Piper Aircraft Corporation

November 17, 1971

Reason for Revision:

Engine Controls Support Bracket Assembly Inspection

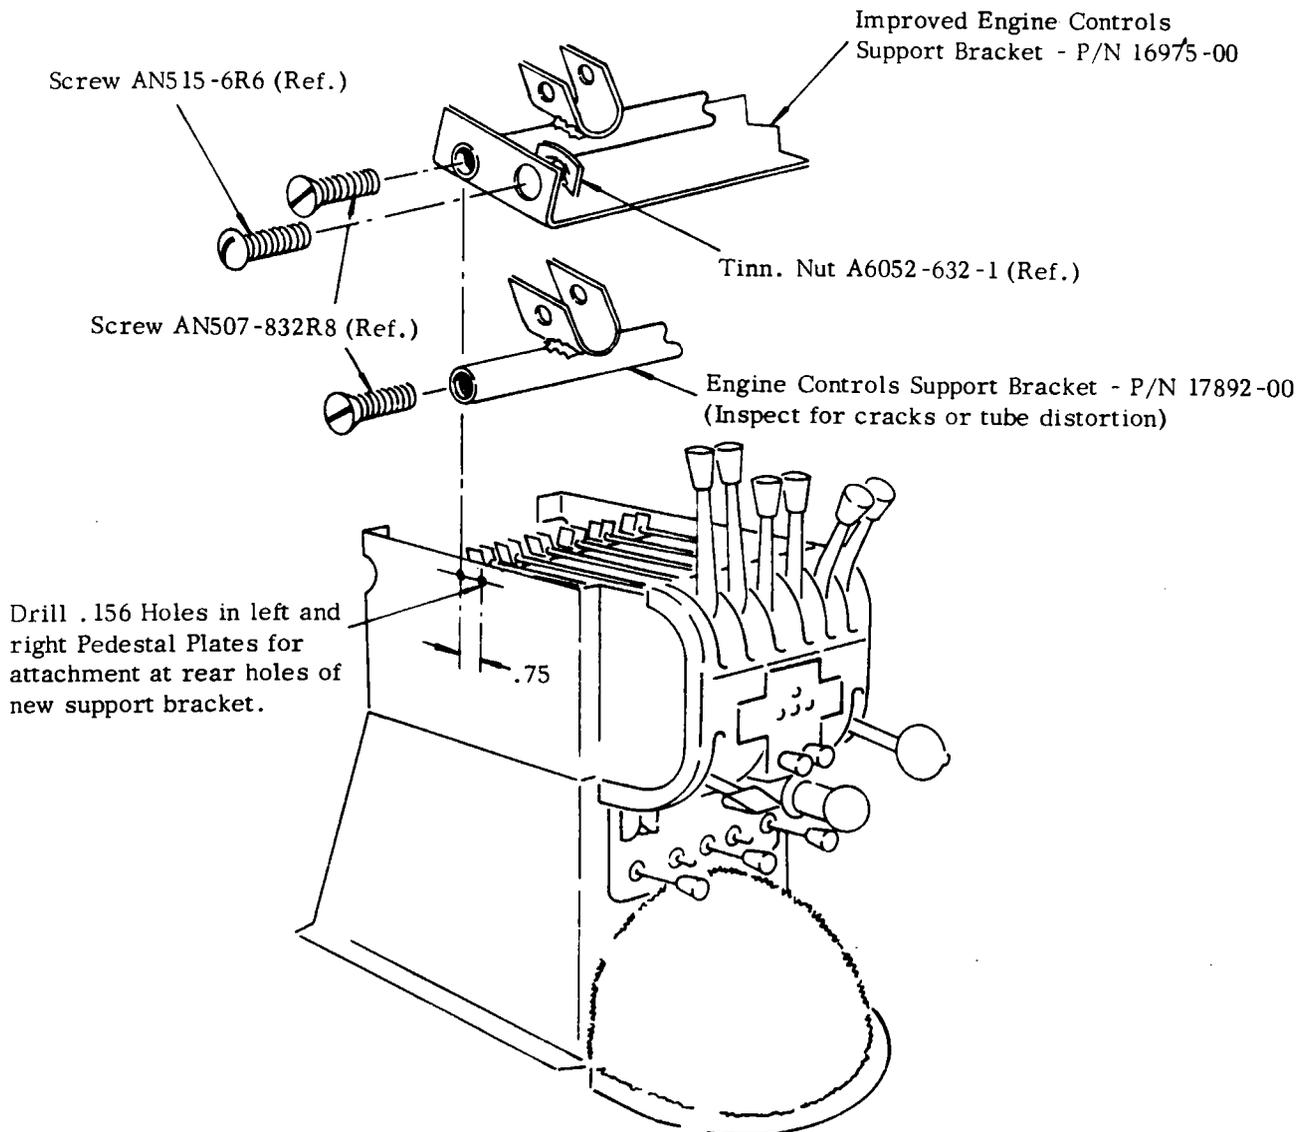
1. Several recent reports from our field organizations concerning the appearance of cracks on the engine control support bracket assembly on relatively high time aircraft indicate the need for a detailed inspection of the assembly in accordance with the information contained in the sketch/instruction sheet on the reverse side of this bulletin.

- Inspect the engine controls support bracket assembly, P/N 17892-00 to ascertain that the tube is not cracked or bent.
- Should inspection reveal a bent or cracked tube, it will be necessary to remove the existing bracket assembly and install an improved bracket assembly, P/N 16975-00.

- Should the inspection reveal cracks and/or tube distortion, the existing engine controls support bracket assembly must be replaced with the improved Piper part number 16975-00 Engine Controls Support Bracket Assembly.
